DA 2021-129 – File Note Flood Impact Assessment

Authors: Peter Chambers (Chief Engineer) & Hamish McTaggart (Development Coordinator)

Date: 24 February 2023

- The images below are taken from Appendix B of the EMM Flood Assessment and show PMF flood depth and velocity depth product.

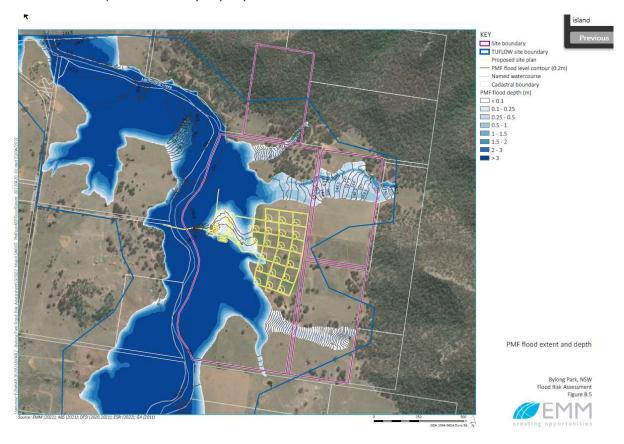
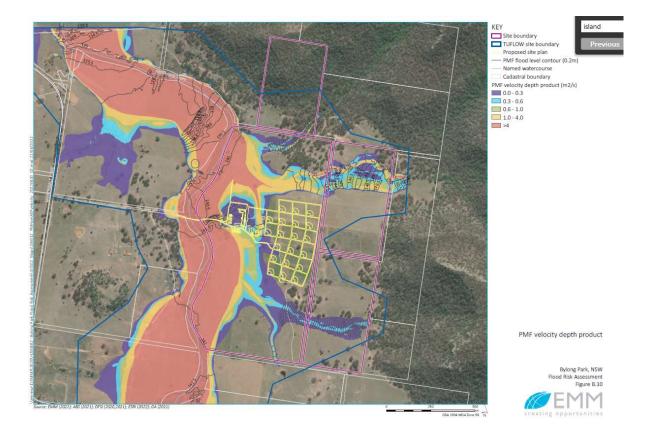
- Existing site dwellings and infrastructure (141m AHD) are situated approximately 6m above the Martindale Creek 1% AEP flood level.
- ➤ The PMF extent inundates the location of the proposed farmstead building by up to 0.3m. The corresponding velocity depth is less than 0.3m2 indicating a low flood hazard category (category H1) near the proposed building.

- ➤ The PMF flood extent is shown to inundate four of the proposed animal kennel areas. Flooding in the PMF primarily impacts the outdoor areas of the kennels and not the buildings. Only one kennel building experiences flooding in the PMF with depths up to 0.1 m. The 2022 Flood Risk Assessment references that it is expected the finished floor level of the kennel buildings will be above the PMF flood level.

- ➤ The peak velocity depth product at the existing site access road causeway exceeds the safe access thresholds established in Section 4.2 in all events modelled, ranging from 3.4 m2/s in the 63.2% AEP event to 7.2 m2/s in the 1% AEP event.

- Requirement for the dog kennel within the PMF area to be constructed above the anticipated extent of the PMF (draft condition 20).
- Detailed design of Flood Warning Response system with the Construction Certificate and implementation through development (draft condition 15).

Figure 4.7 Number of site access restricting streamflow events per year

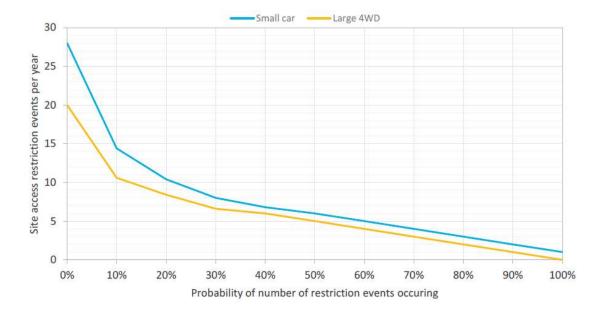
- It was anticipated that streamflow events that would restrict safe site access for large 4WD and small vehicles would occur more than five and six times per year in 50% of years.

- o More than 10 events per years are expected to occur in 10% of years.
- For 50% of events, safe access would be restricted to approximately 1 day for large 4WD vehicles and 1.5 days for small cars.

Figure 4.8 Duration of site access restrictions during a streamflow event

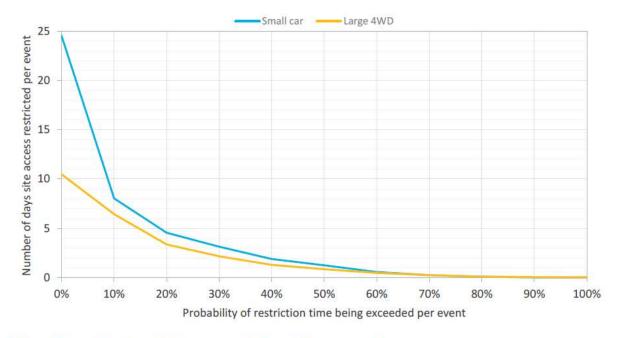
- o Approximately 10% of events would restrict site access for more than 6 days.
- The graphs below have been taken from the EMM Flood Risk Assessment May 2022 and respectively the number of site access restricting streamflow events per year and the duration of site access restrictions during streamflow events.
